Re: CEMEX South Cement Plant Alternative Fuel/Material Processing Facility
Pending Permit #22787-004-SO/31
WACS: 40778, Brooksville, Hernando County, Florida

Thank you for meeting with representatives of CEMEX Construction Materials Florida, LLC (CEMEX) and Koogler and Associates, Inc. (Koogler) on January 16, 2012 to discuss the Department's request for additional information (RAI) dated December 13, 2012. On behalf of CEMEX, Koogler is responding to the RAI. The RAI items and our responses are as follows:

Figure 1 - Site Plan
AFM Storage/Processing Locations
CEMEX Brooksville South-Alternative Fuel Material
Permit Application, 62-701, FAC
Brooksville, Hernando County, FL

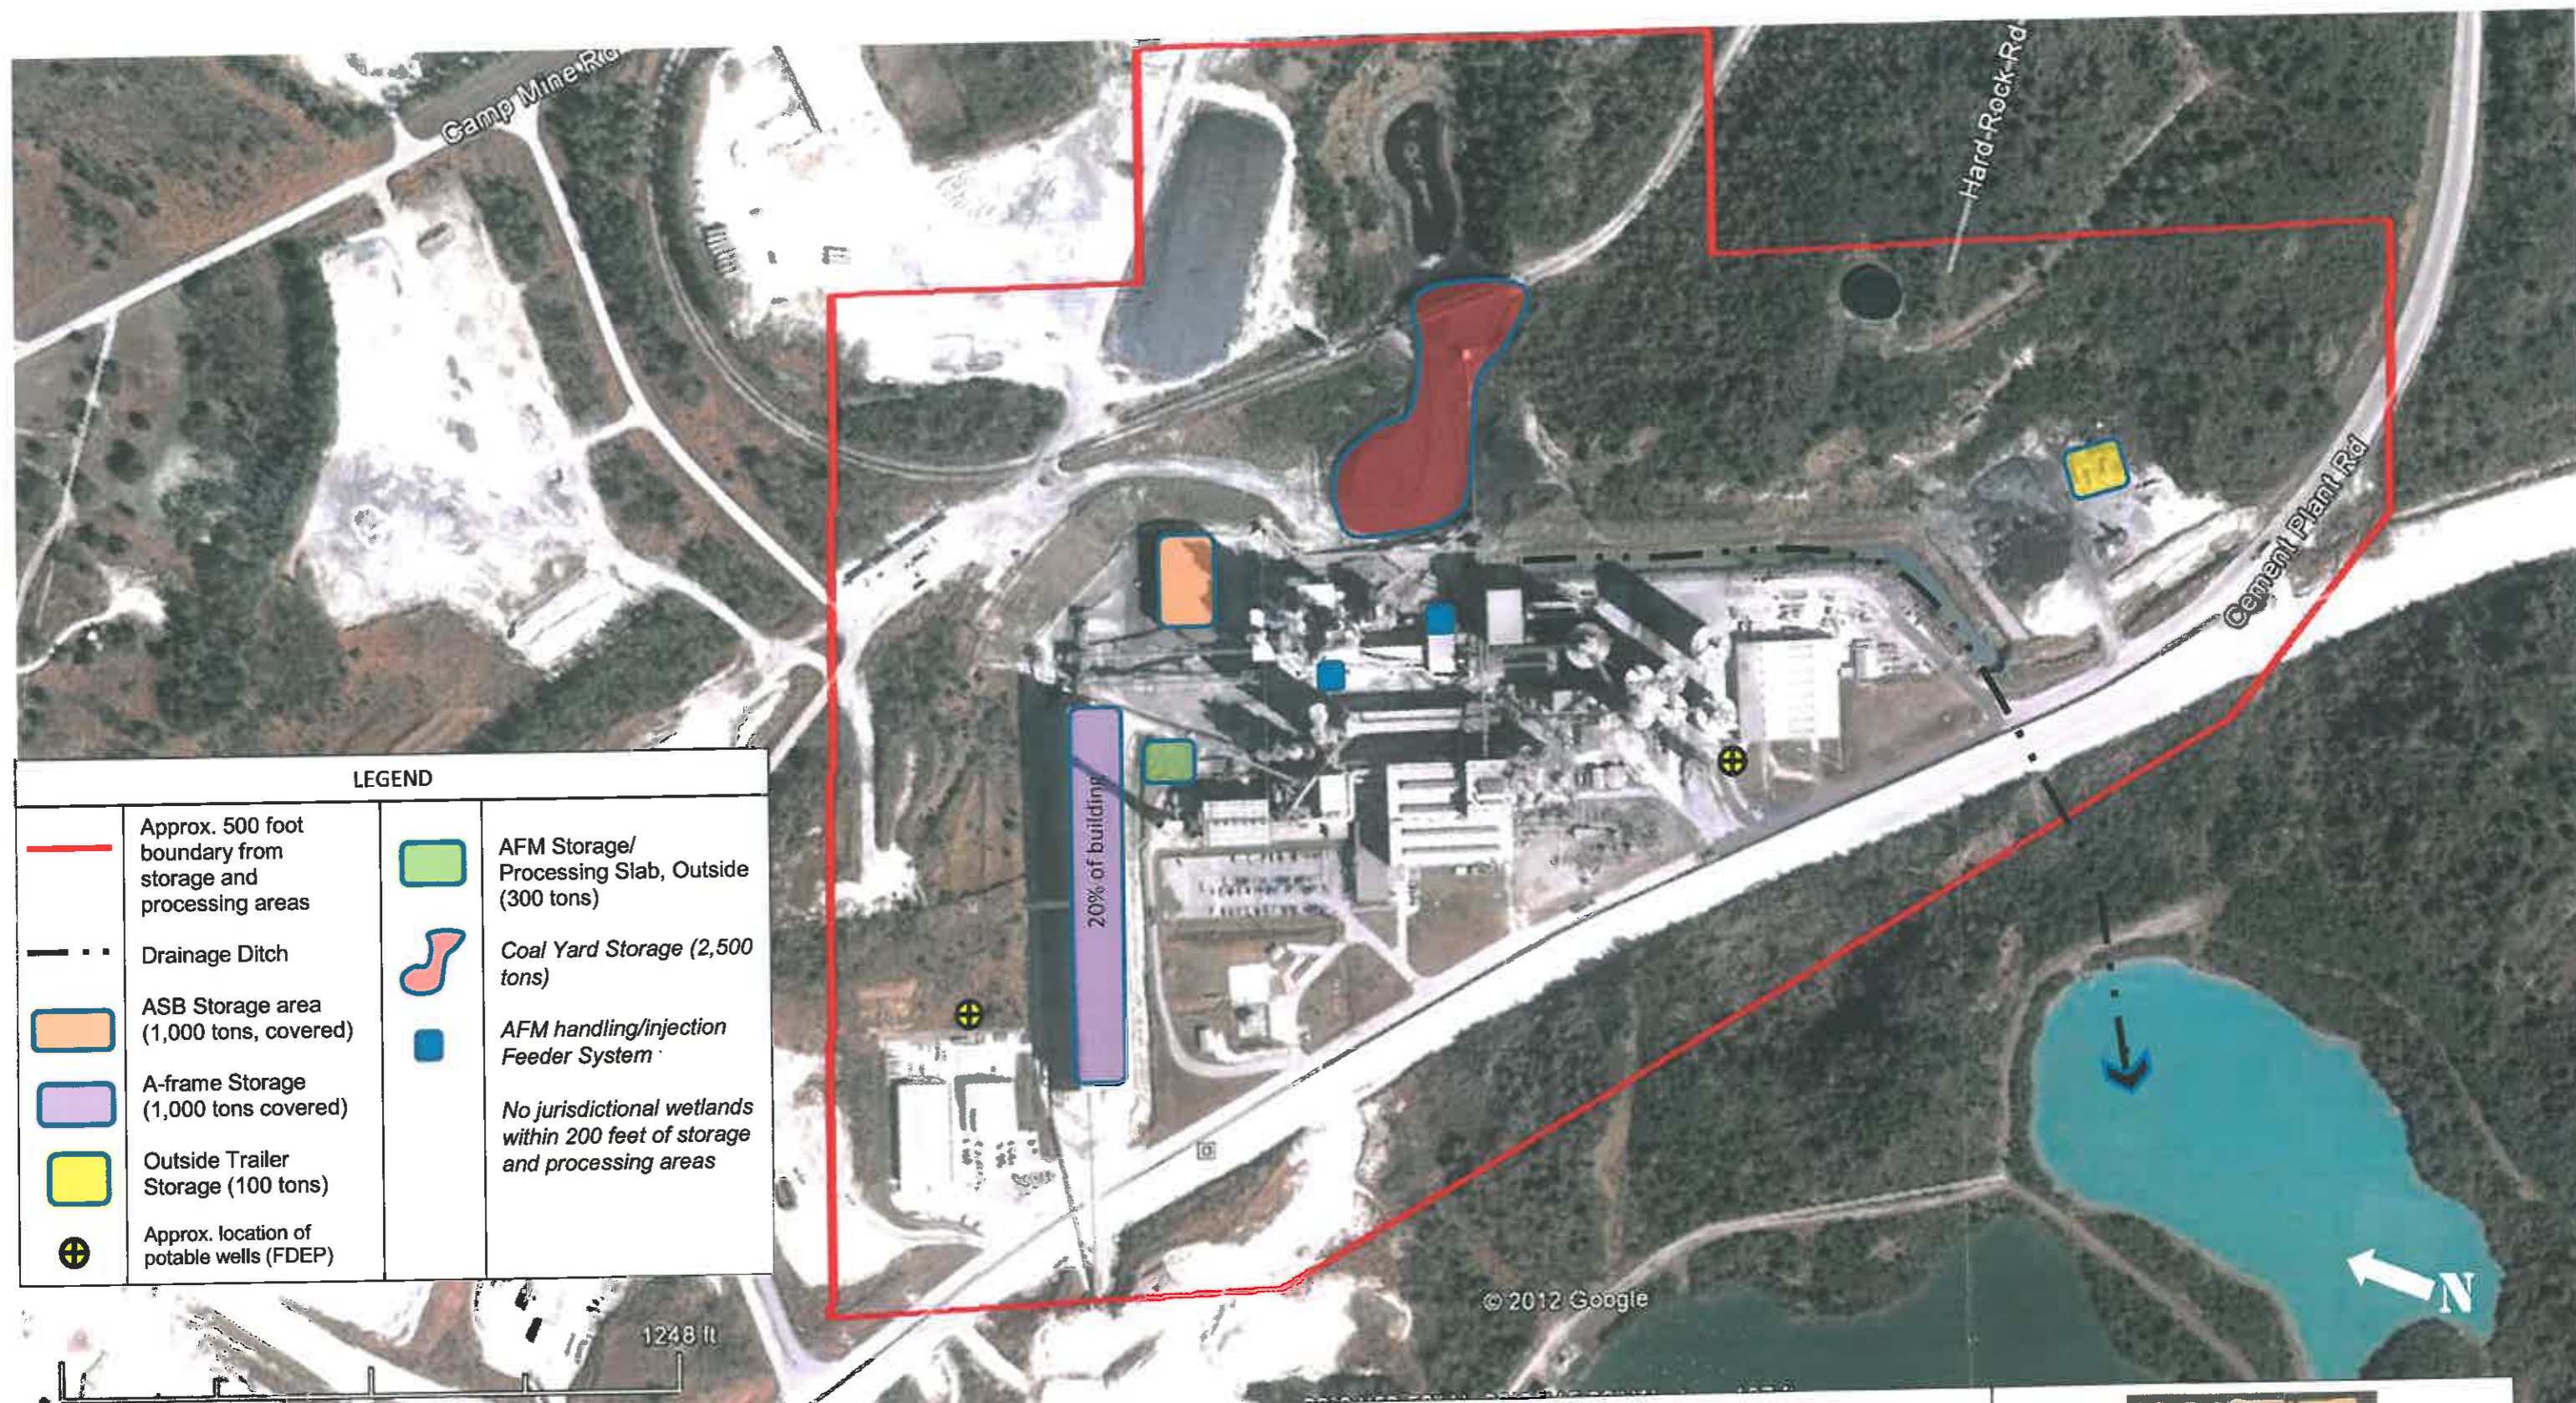
4. *"Section 3.3: Please identify the location of the AFM handling/injection feeder system on Figure 1 – Site Plan."*

Response: Figure 1 has been revised to include the location of the AFM handling/injection feeder system (Attachment 2).

Figure No. 1

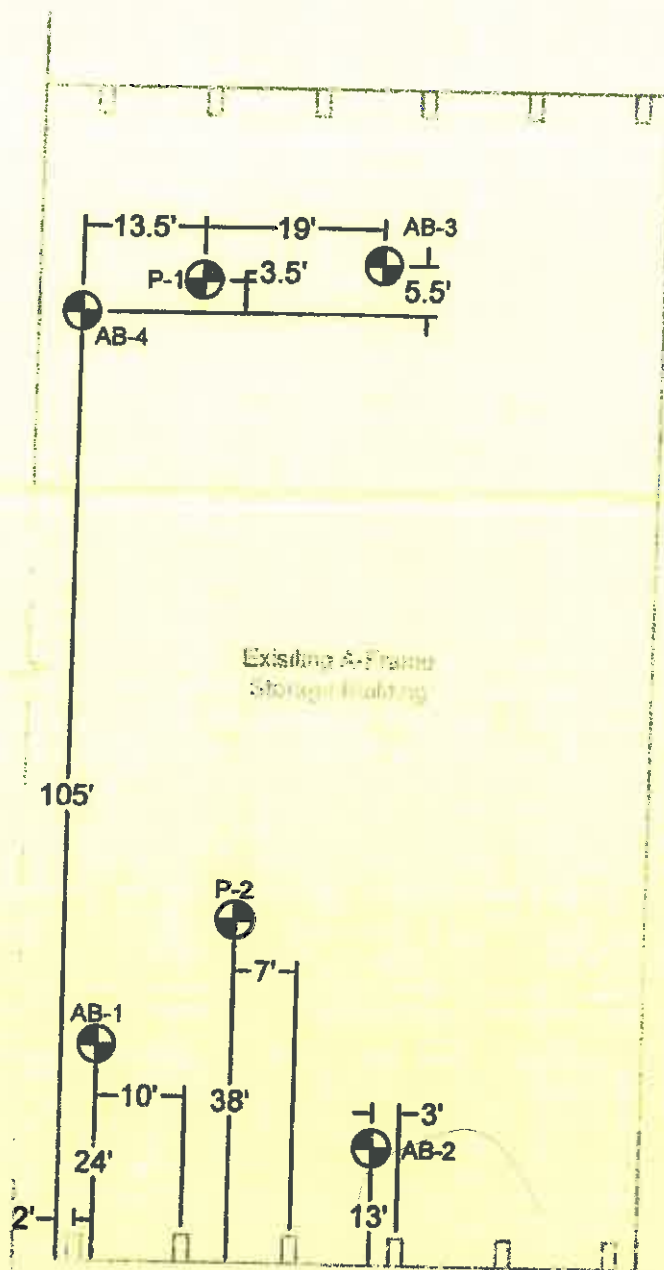
- b. *A-Frame Building (AFB): Please revise this section to specifically describe the construction details of the floor (e.g. material type, thickness, sealant, ..."*

Response: The floor of the A-Frame Building is an impervious surface which according to boring logs varies in composition of:

- **between 6 inches and 1 foot 6 inches of compacted limestone, beneath which lies between 2 feet 6 inches to 4 feet 6 inches of clay; or**
- **over 4 feet of clay**

Either hard rock or limestone was encountered at each boring at a depth of between 4 and 5 feet. Two permeability tests were performed at depths of 12 to 14 inches below the existing ground surface which resulted in the determination that the floor of the A-Frame Building is impervious. The report with boring logs and methodology of the soil sampling is provided as Attachment 4.

FLORIDA CRUSHED STONE COMPANY BROOKSVILLE, FLORIDA	
AREA 141	ADDITIVES STORAGE BLDG
SUBJECT STRUCTURAL ELEVATION

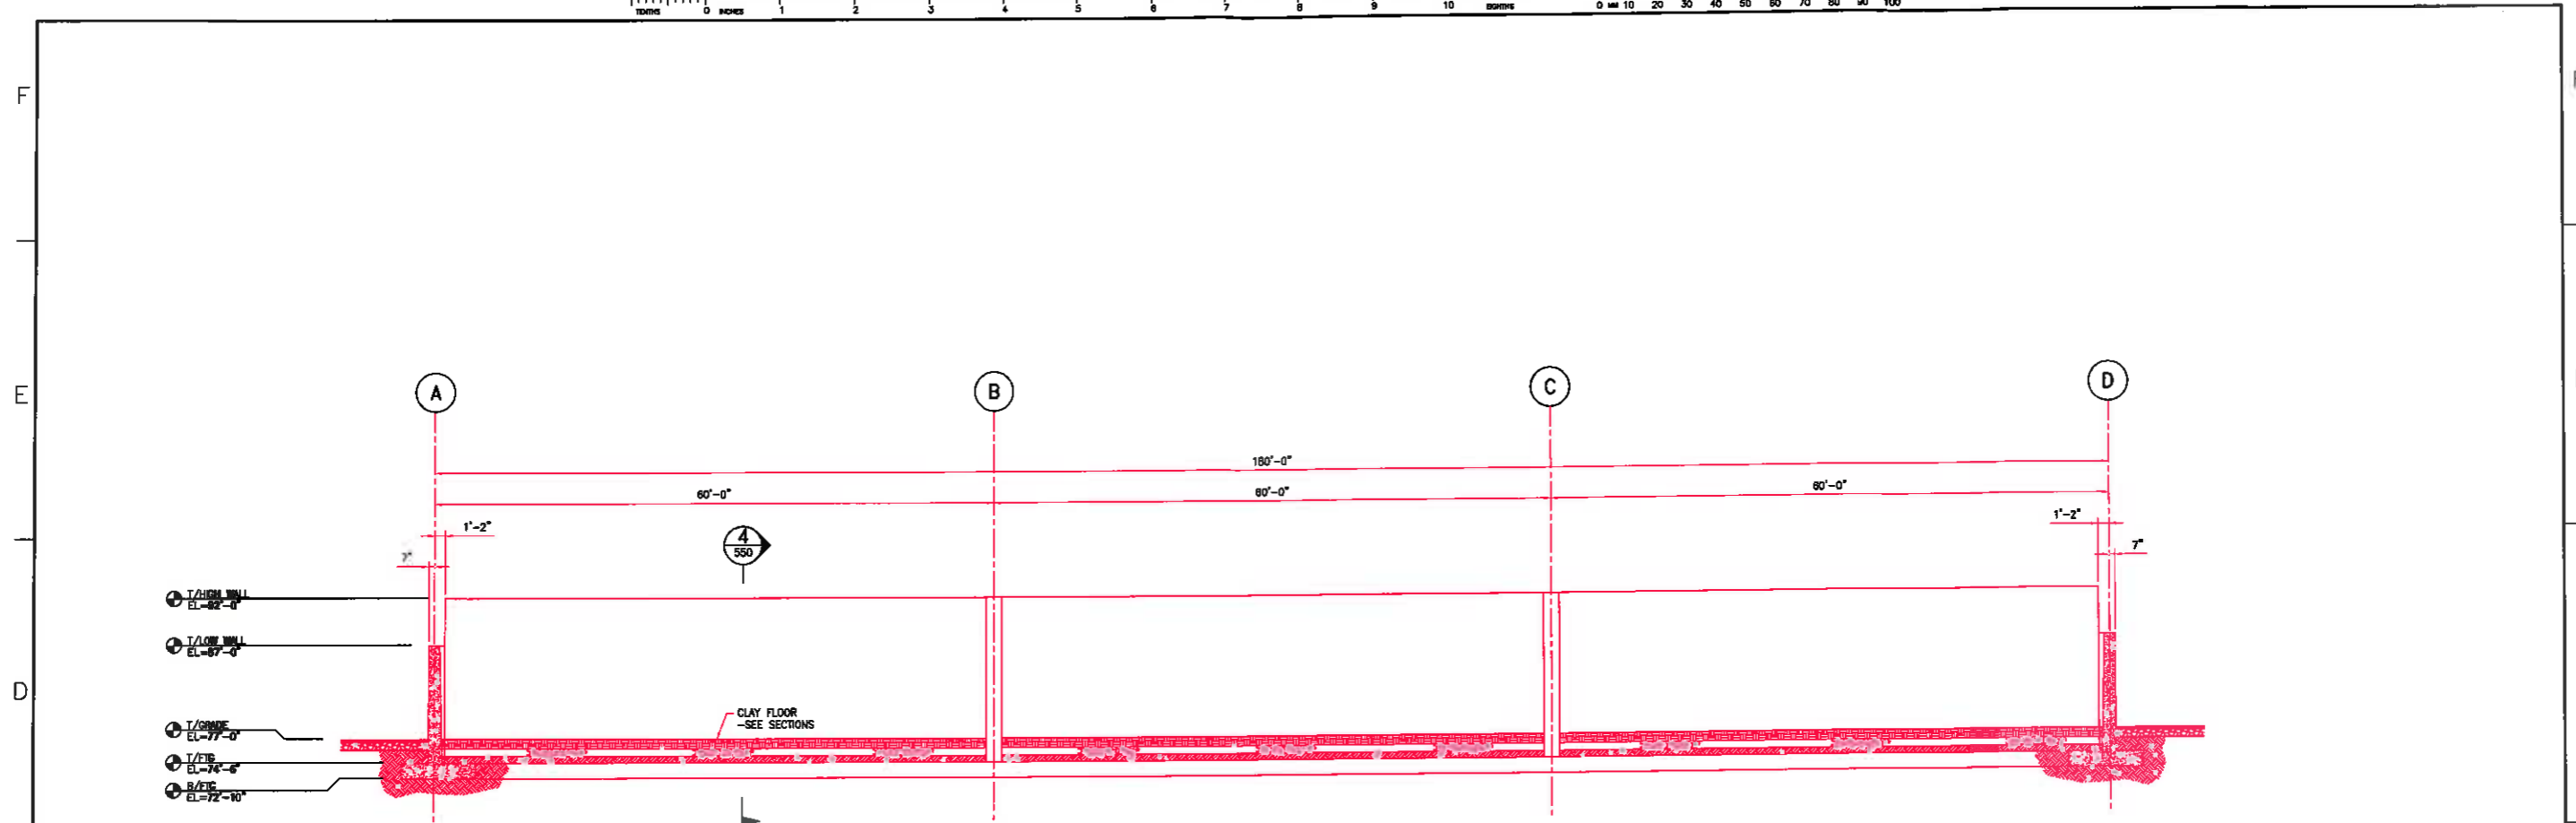
- c. *Additive Storage Building (ASB): Please revise this section to specifically describe the construction details of the clay floor (e.g. clay type, thickness, ..."*

Response: The floor of the ASB is compacted subgrade material overlain by 10 inches of compacted graded aggregate which is overlain by 12 inches of clay. We believe that the permeability tests performed on the floor of the A-Frame Building, which is constructed of similar materials, provides a basis for assurance that the floor of the ASB is also impervious. The structural details of the ASB are provided as Attachment 5.
